ADDENDUM NO. 1

May 6, 2022

LIBERTY INTERMEDIATE SCHOOL ADDITIONS AND RENOVATIONS
Chesterton, IN 46304

This Addendum consists of Pages ADD 1-1 through ADD 1-3 and attached Addendum No. 1 from Gibraltar Design dated May 5, 2022 and consisting of 7 pages, Specification Section 07 53 25 - Single-Ply Roofing Rehabilitation, and 99 drawings.

DRAWING
SCIENCE CASEWORK SCHEDULE, ELEVATIONS AND DETAILS

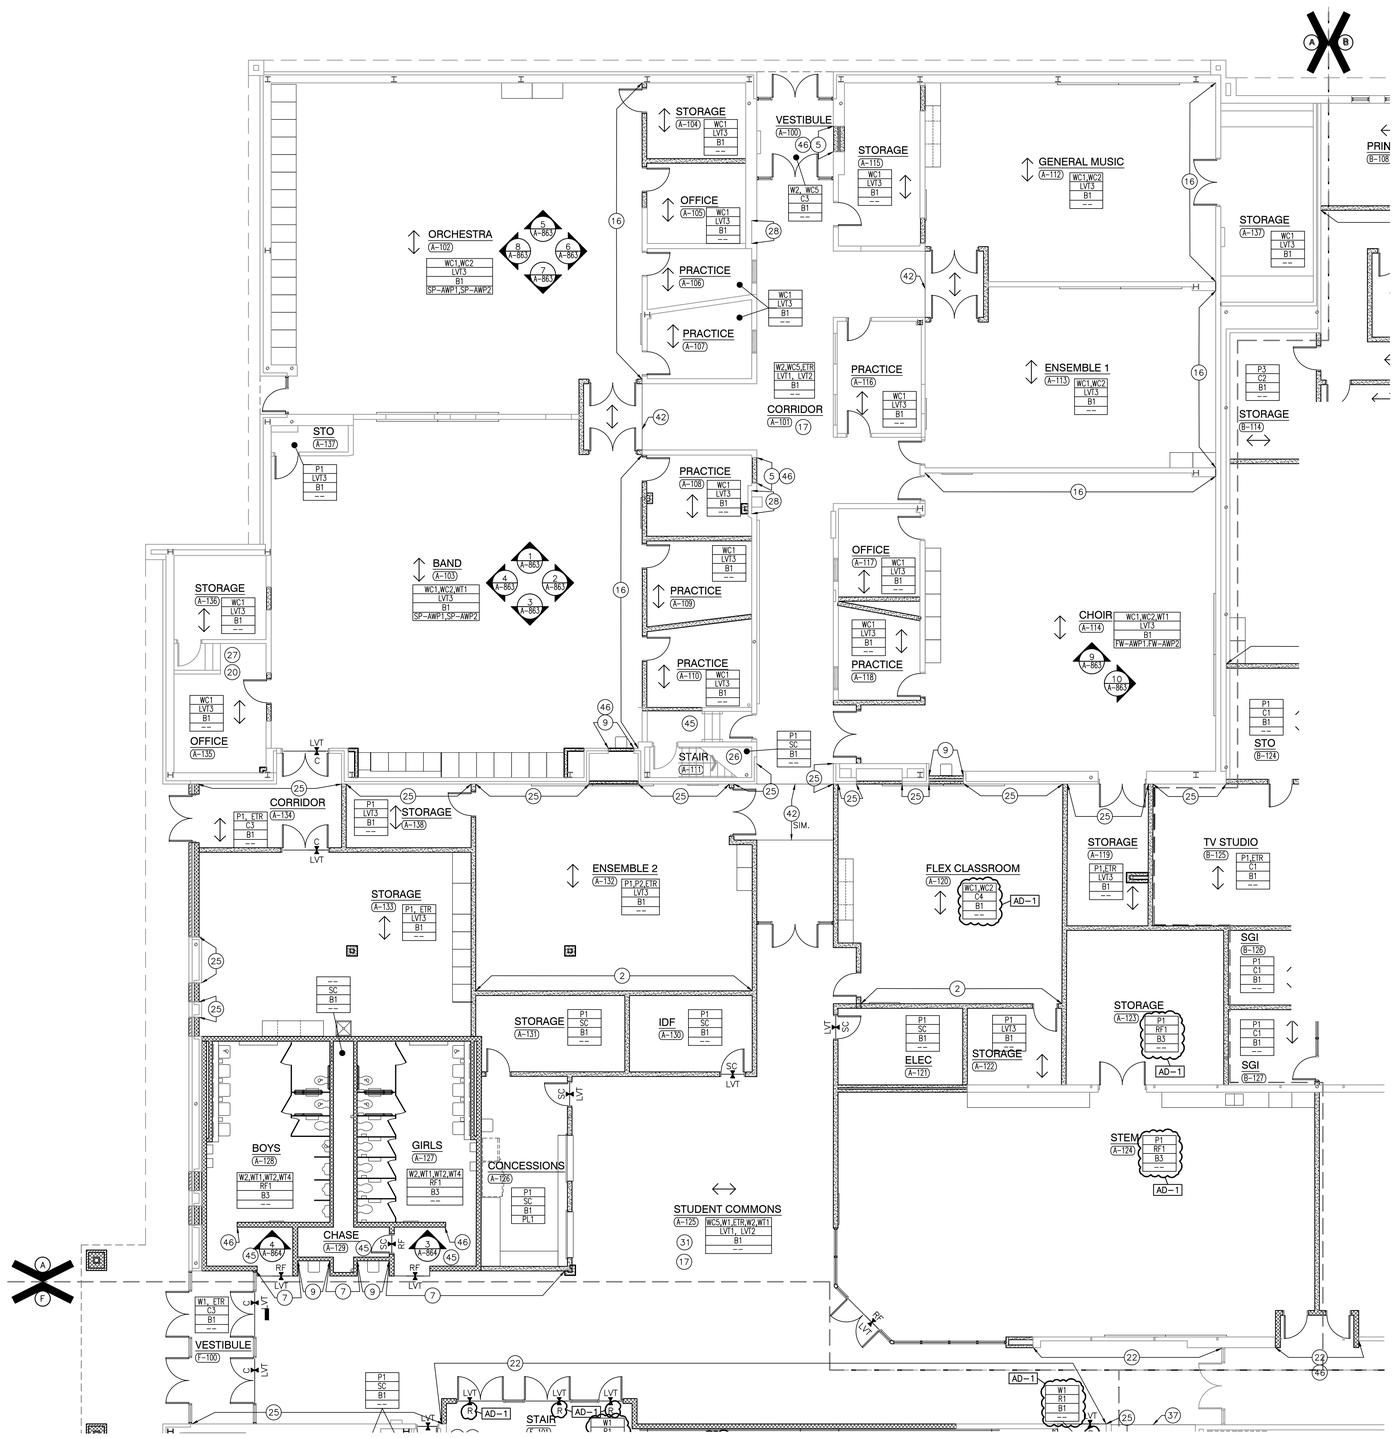
22. Sheet A-740

A. Refer to revised full-size drawing, included in this Addendum, for revised Science Casework Schedule.

SHEET
FP-001

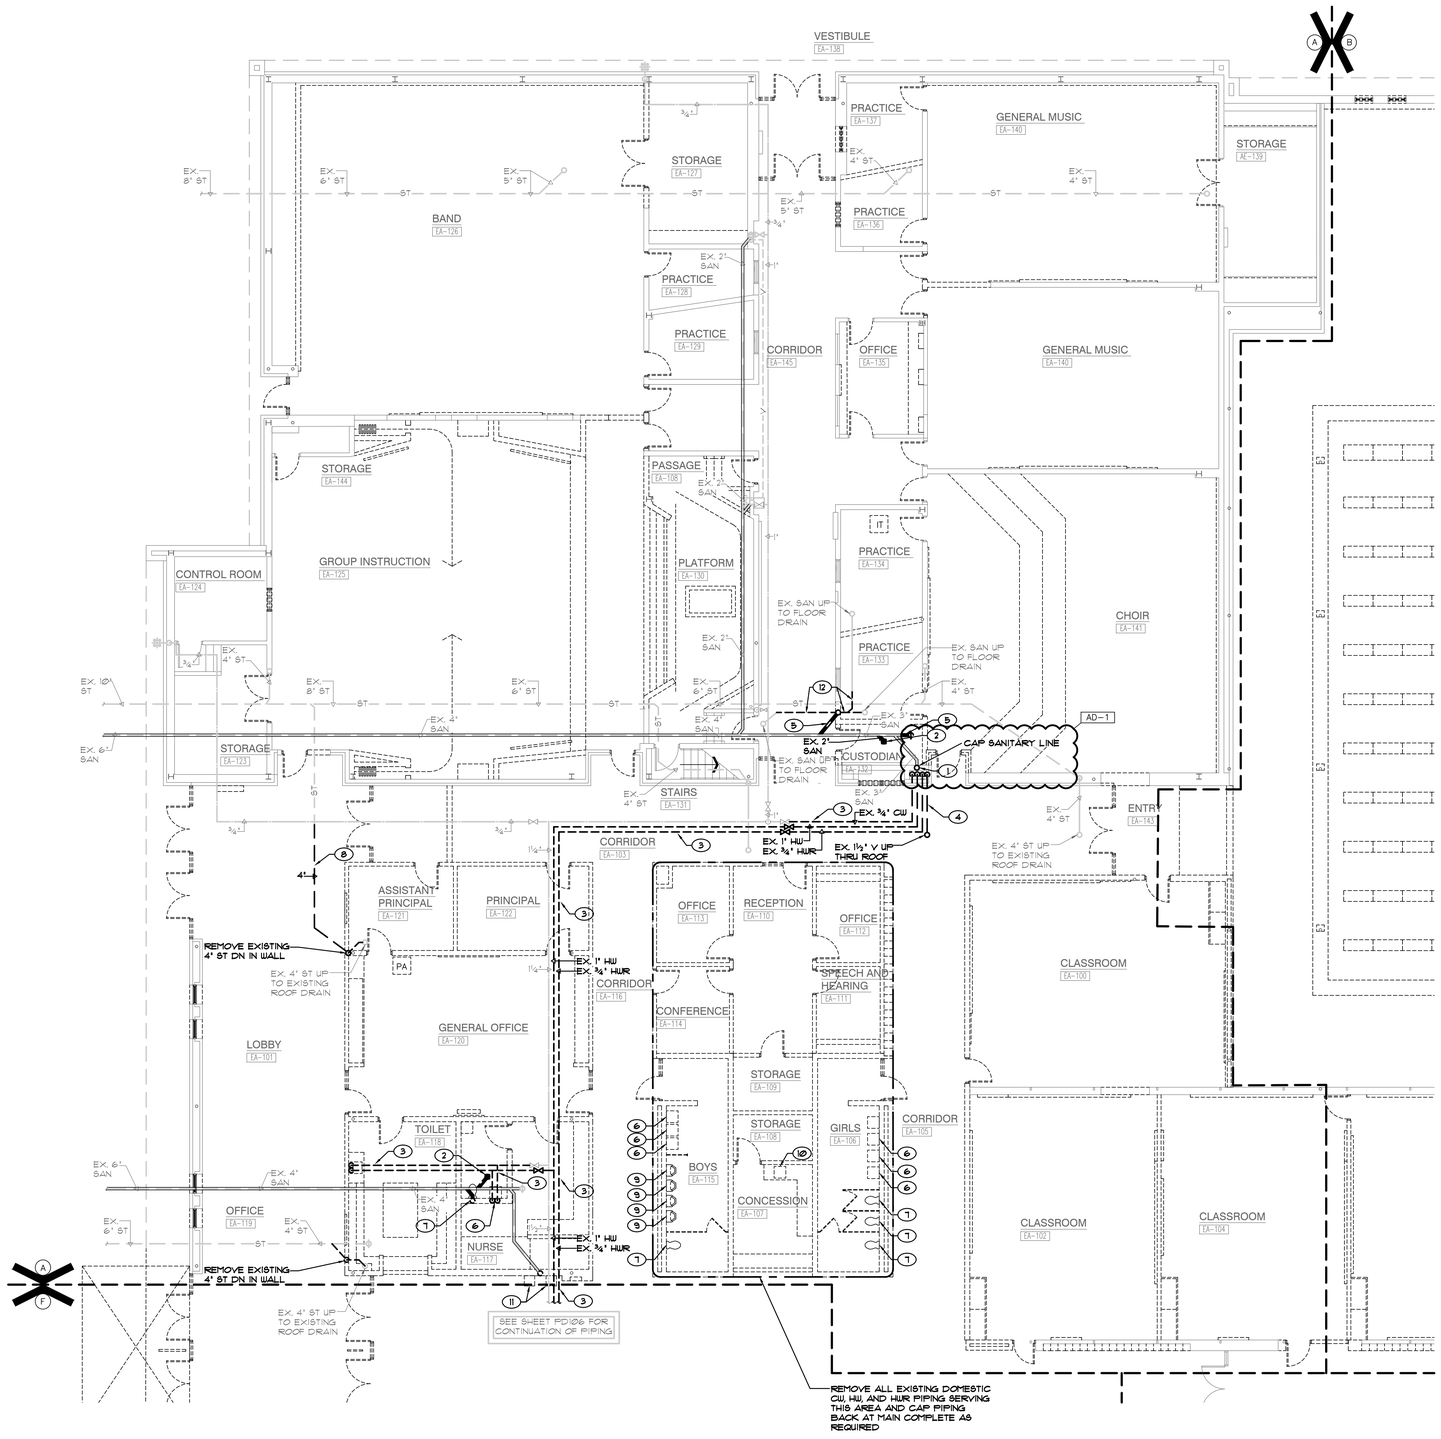
26. Sheet FP001

A. Refer to revised full-size drawing, included in this Addendum, for the following revisions.

1. Added note for existing fire protection zones to remain.
2. Added note to extend new fire protection piping to existing zone mains.
3. Revised Fire Protection General Notes.
4. Revised Inspector's Test Pipe Detail.

SHEET
A PD101

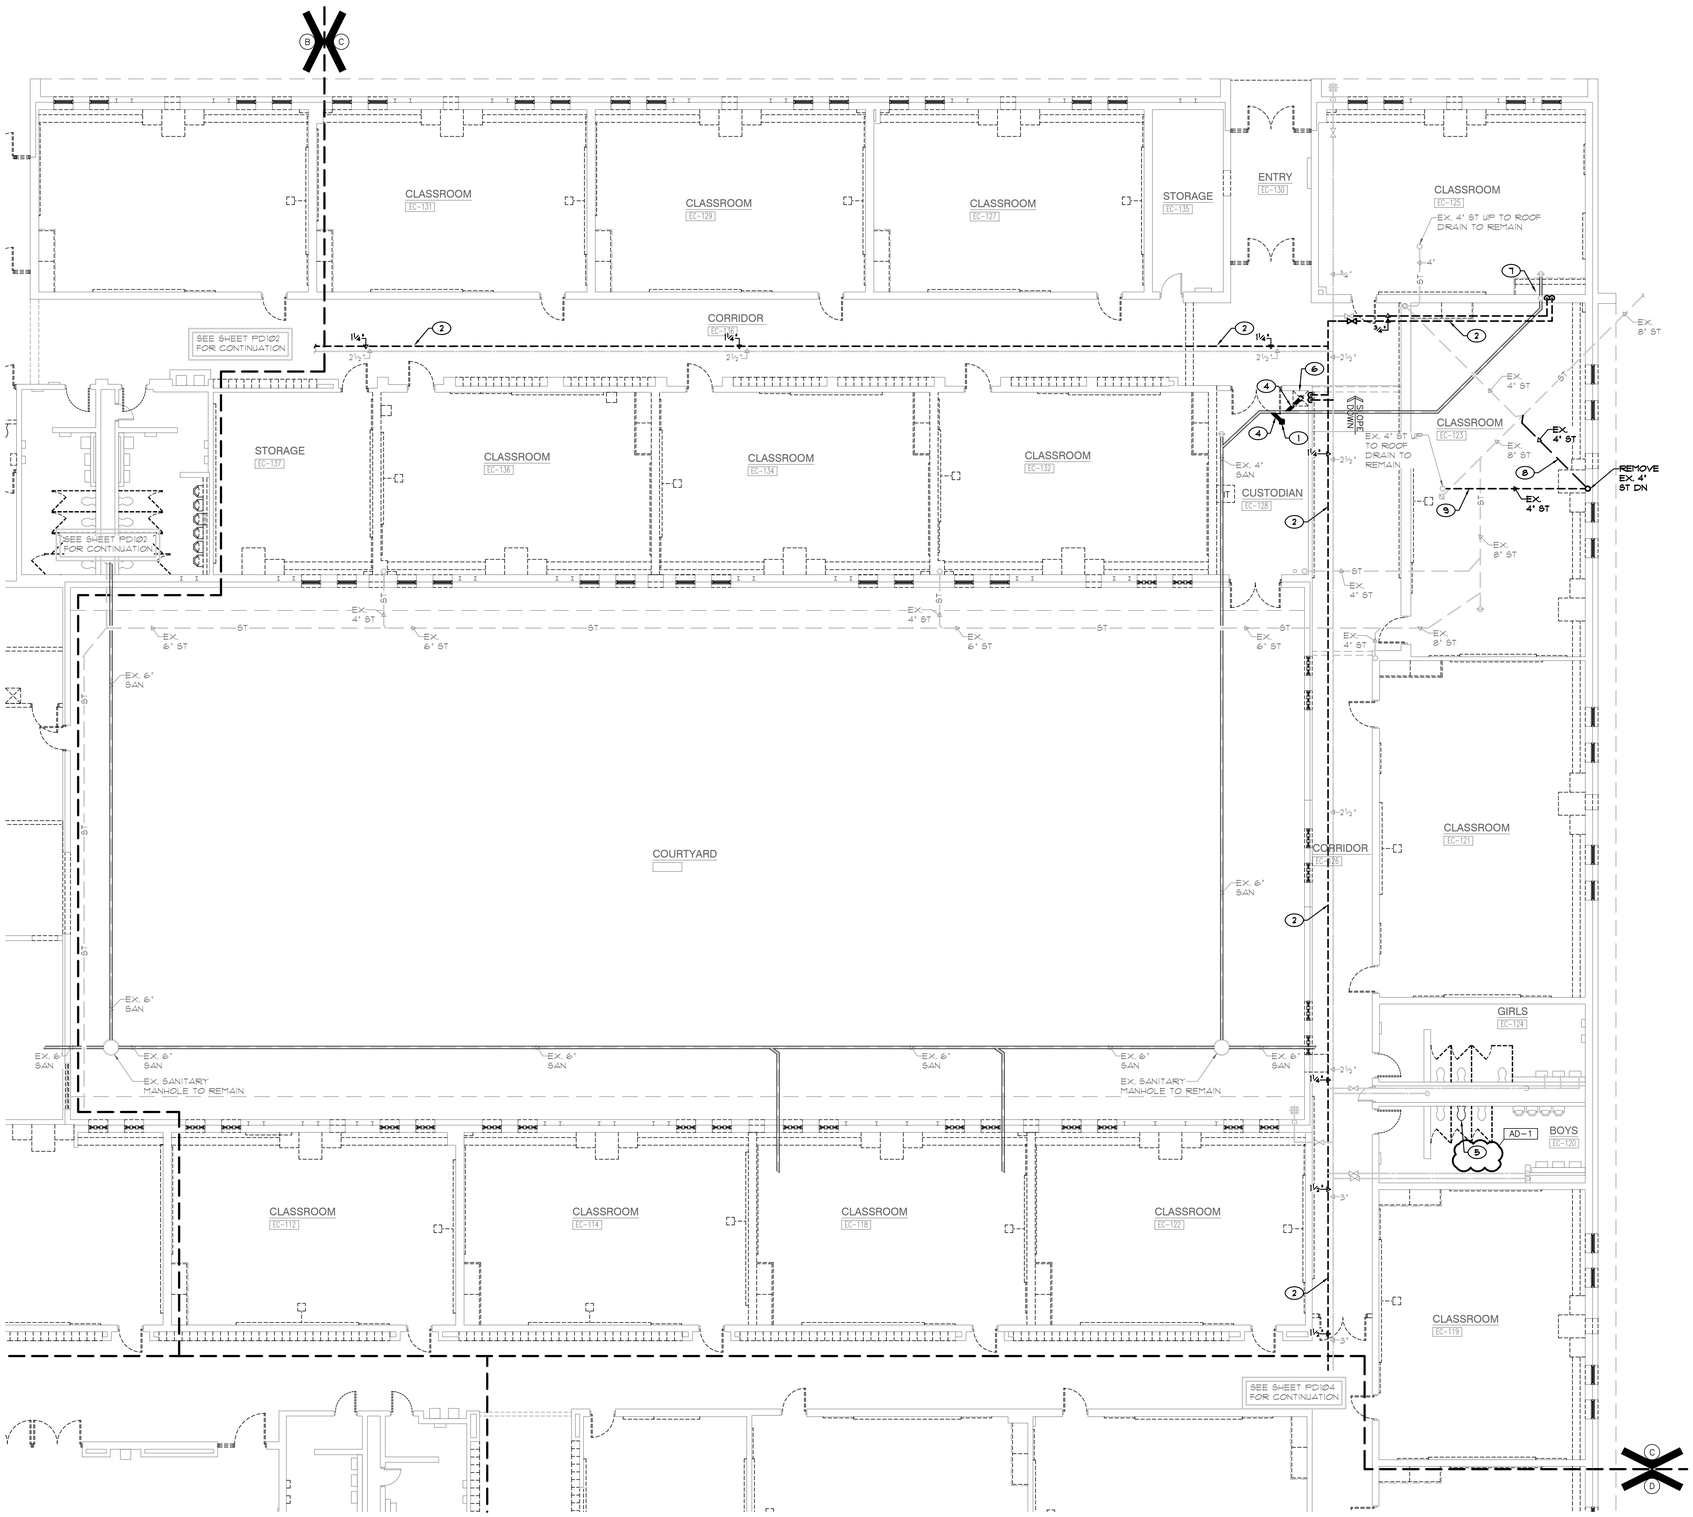
27. Sheet PD101

A. Refer to revised full-size drawing, included in this Addendum, for note added to cap sanitary line.

SHEET P-105

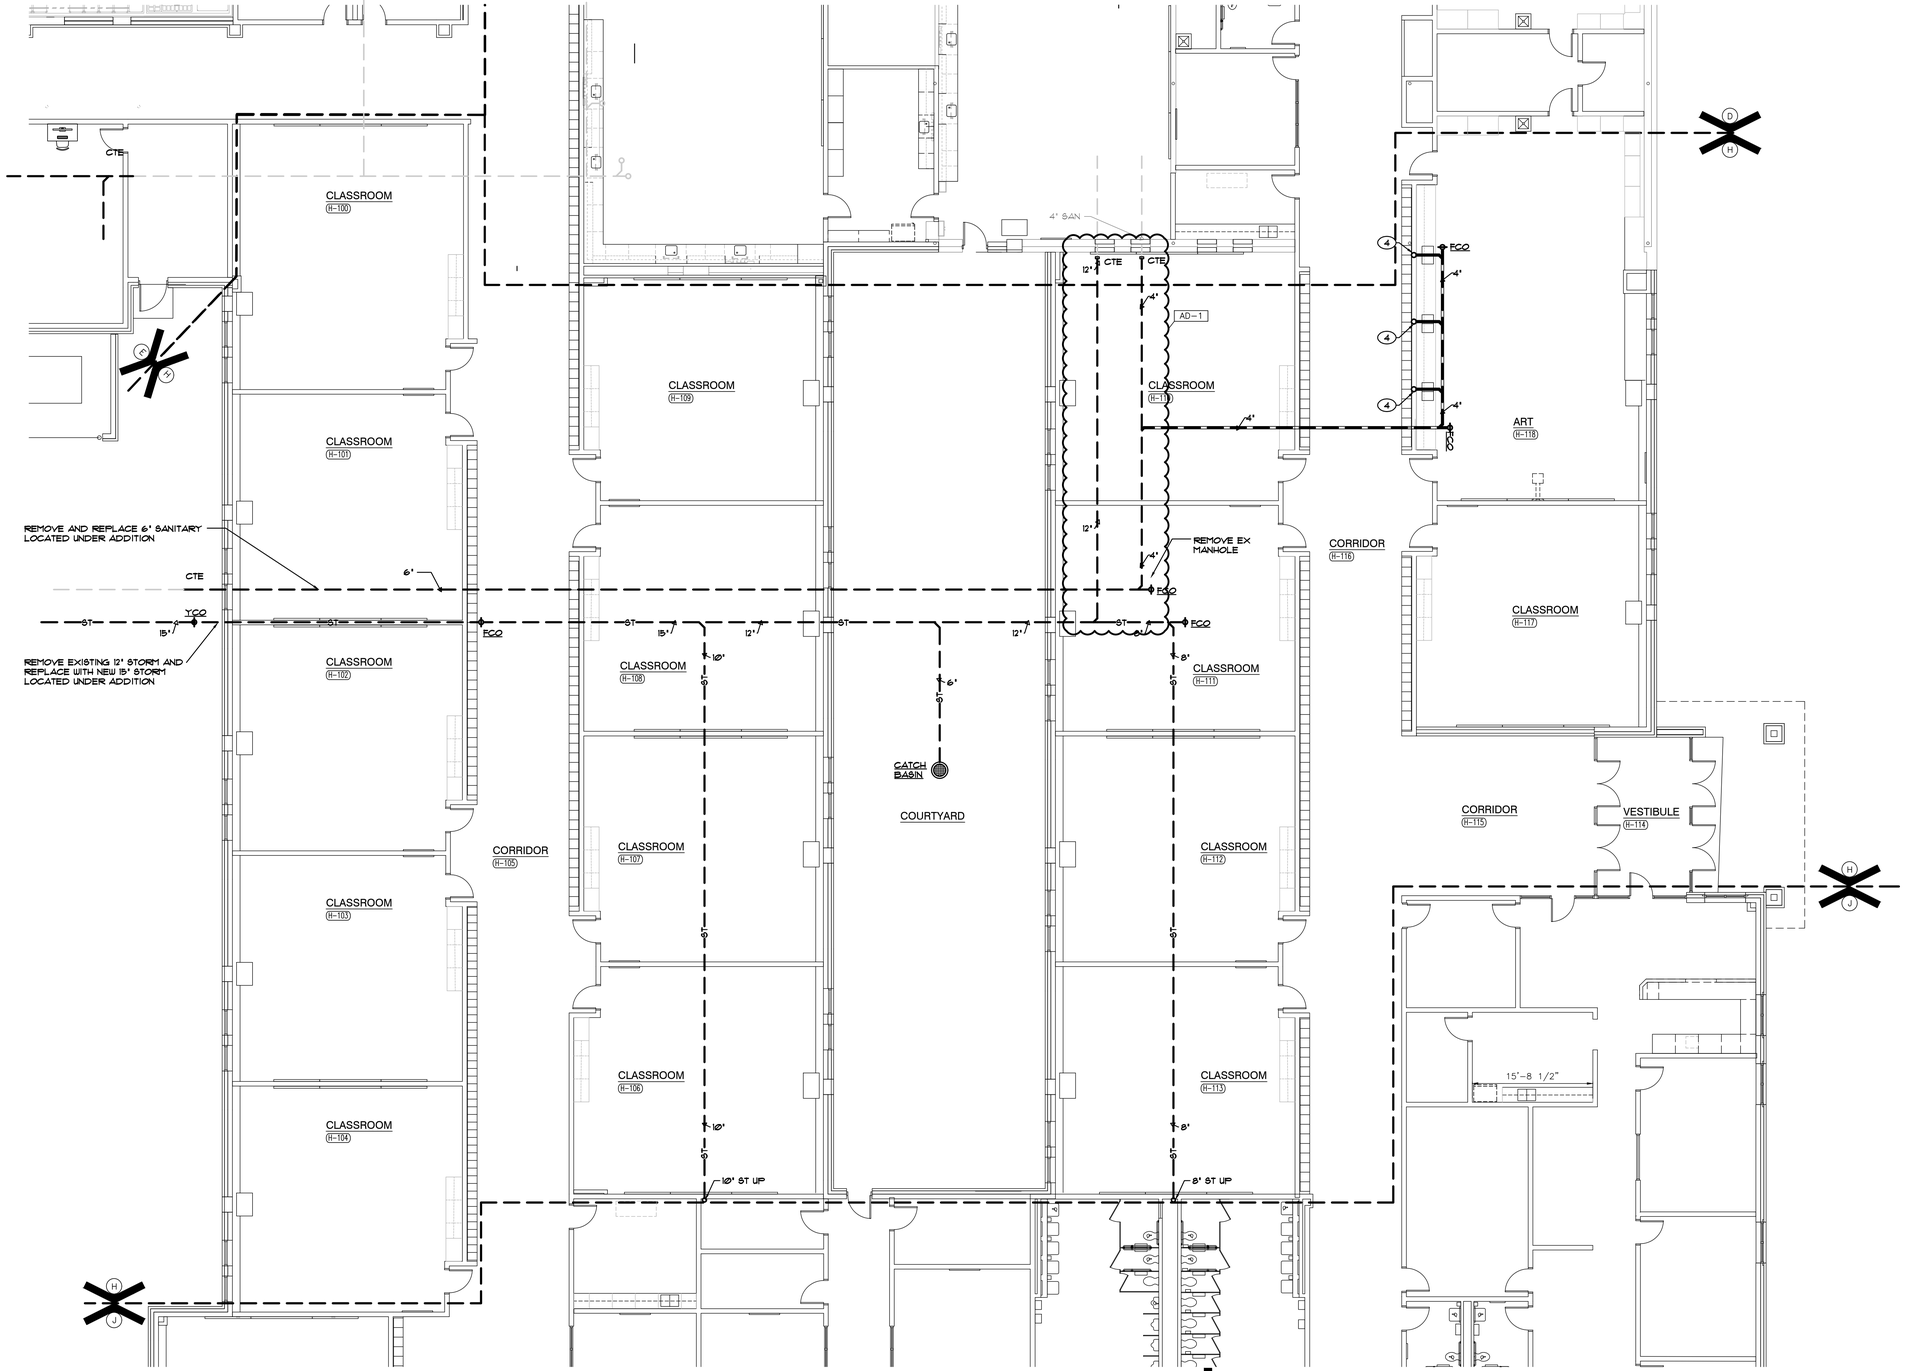
31. Sheet P-105

A. Refer to revised full-size drawing, included in this Addendum, for revised sheet note tagging.

SHEET
H
P-108

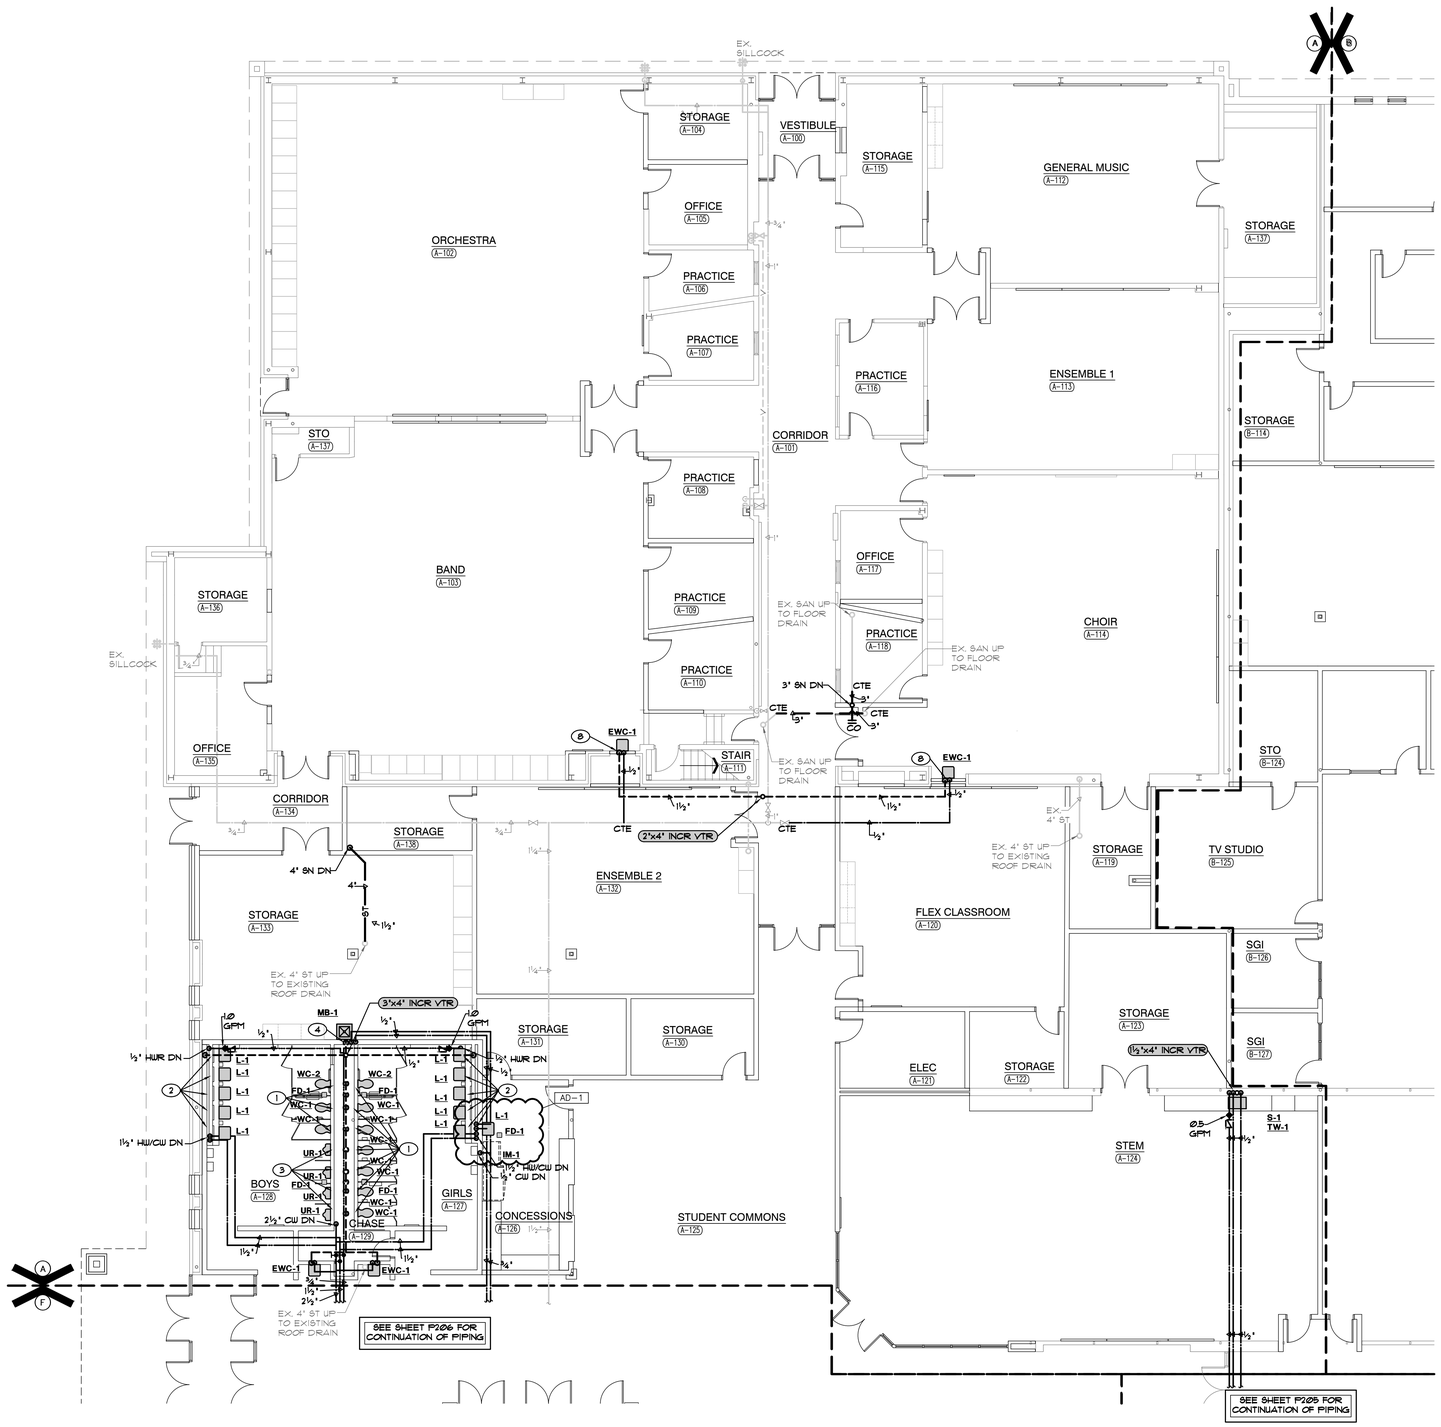
32. Sheet P-108

A. Refer to revised full-size drawing, included in this Addendum, for revised connect point of new to existing storm and sanitary piping.
